# Access Compliance Report

## Public Rights-of-Way

### (Curb Ramps)

Intersection ID: 31864	Main Street: ARABELLA_DR	Cross Street: LANGDEN_GATE_DR	Location: SW
ADA ID: A24F8669649A	Ramp Type: BlendTrans1	Initial Pass/Fail: Fail	Overall Compliance: No
		Severity Score: 10

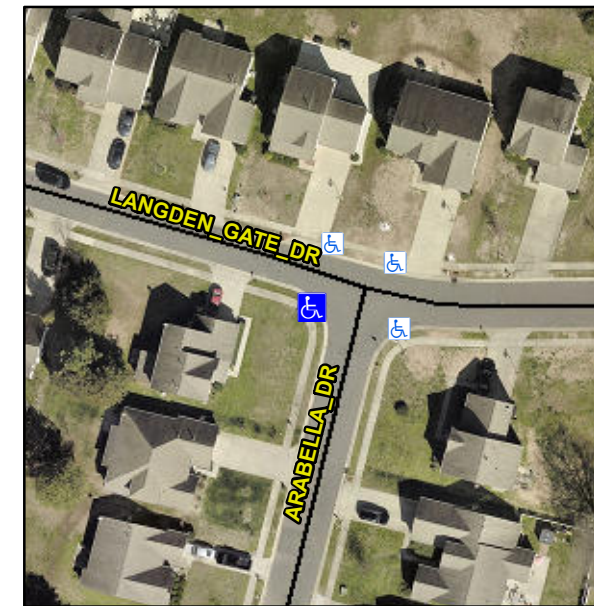
**R304.5.1, R304.5.3**

Compliance	Description	Data	Compliance	Description	Data
N/A	Ramp Length (in)	50.0	Yes	BlendTrans Slope (%)	4.2
No	Ramp Width (in)	43.0	No	BlendTrans XSlope (%)	3.2
N/A	Flare Type LT	N/A	N/A	Flare Type RT	N/A
N/A	Flare Slope LT (%)	N/A	N/A	Flare Slope RT (%)	N/A
N/A	Flare Traversable LT?	N/A	N/A	Flare Traversable RT?	N/A
N/A	Landing Length (in)	N/A	N/A	DWS Provided?	N/A
N/A	Landing Width (in)	N/A	N/A	DWS Contrast?	N/A
N/A	Landing Slope (%)	N/A	N/A	DWS Length (in)	N/A
N/A	Landing X Slope (%)	N/A	N/A	DWS Full Width?	N/A
N/A	Landing Curb? (Y/N)	N/A	N/A	DWS Offset (in)	N/A
N/A	Shared Landing?	N/A			
N/A	Gutter Ponding?	N/A	N/A	Gutter Slope (%)	N/A
N/A	Gutter Lip Ht (in)	N/A	N/A	Gutter X Slope (%)	N/A
N/A	Painted X Walk1?	No	N/A	Painted X Walk2?	No
	X Walk 1 Direction	To SE		X Walk 2 Direction	To NE
	X Walk 1 Width (in)	N/A		X Walk 2 Width (in)	N/A
	X Walk 1 Slope (%)	3.3		X Walk 2 Slope (%)	4.7
	X Walk 1 X Slope (%)	4.2		X Walk 2 X Slope (%)	0.3

**Remove & Replace Curb Ramp With Two New Directional Ramps or Equivalent.**
